Access Compliance Report

Public Rights-of-Way

Intersection ID: 13701	Main Street: SPRUCE_ST	Cross Street: WILMORE_DR	Location: NW
ADA ID: B235C156200A	Ramp Type: ParaDiag	Initial Pass/Fail: Fail	Overall Compliance: No
		Severity Score: 25

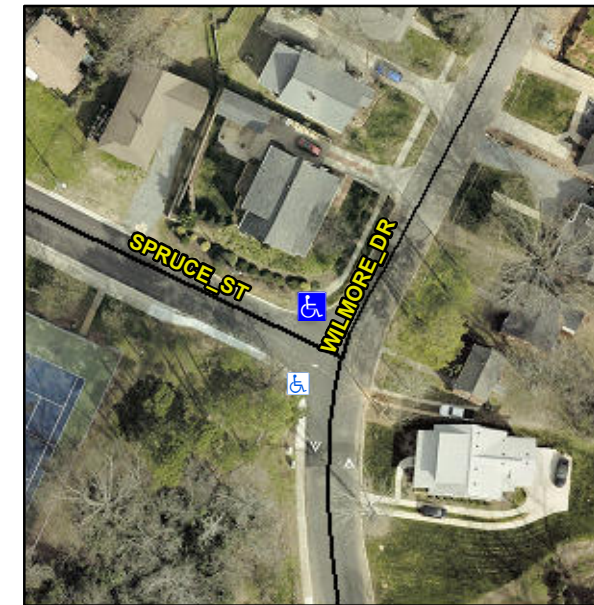
Remove & Replace Curb Ramp With Two New Directional Ramps or Equivalent.

R304.3.2
